<b>Delegated Report</b>		<b>Analysis sheet</b>	<b>Expiry Date:</b>	10/05/2022
		N/A / attached	<b>Consultation Expiry Date:</b>	12/06/2022
<b>Officer</b>			<b>Application Number(s)</b>	
Elaine Quigley			2022/1065/P	
<b>Application Address</b>			<b>Drawing Numbers</b>	
2A Gate Street London WC2A 3HP			See draft decision notice	
<b>PO 3/4</b>	<b>Area Team Signature</b>	<b>C&amp;UD</b>	<b>Authorised Officer Signature</b>	
<b>Proposal(s)</b>				
Erection of an additional storey at fourth floor level (following removal of the roof) and erection of a mansard roof extension to create a new one bedroom self-contained flat (Class C3) with external roof terrace and privacy screen, green roof and alterations to windows on front elevation at third floor.				
<b>Recommendation(s):</b>		Refuse planning permission		
<b>Application Type:</b>		Full Planning Permission

1.1 Planning permission is sought for the erection of single storey extension at fourth floor level (following removal of the roof) and erection of a mansard roof extension to create a new residential flat with external terrace and privacy screen and alterations to windows on front elevation at third floor

Figure 1: Proposed front, side and rear elevations of the refused scheme (ref 2006/5115/P).

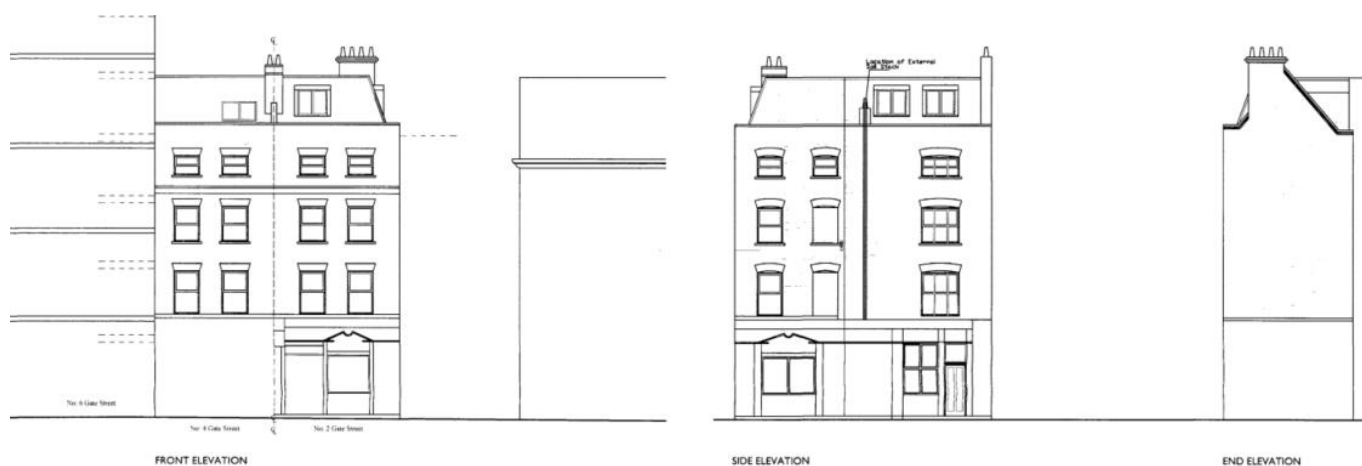
Planning permission was **refused** (ref 2006/5115/P) on 16/04/2007 for alterations to existing roof involving an increase in ridge height and formation of a new dormer window to the front and 2x to the side elevation in connection with the formation of an additional self-contained residential flat (Class C3) at roof level of the existing residential building (Class C3) with ground floor cafe (Class A1) (see figure 1 below illustrating proposal). The 2 reasons for refusal include:

1. design of the dormer windows and the detrimental impact on the character and appearance of the building and this part of Bloomsbury Conservation Area and
2. Inadequate size of the self-contained flat leading to substandard accommodation resulting in detrimental harm to the amenity of future occupiers.
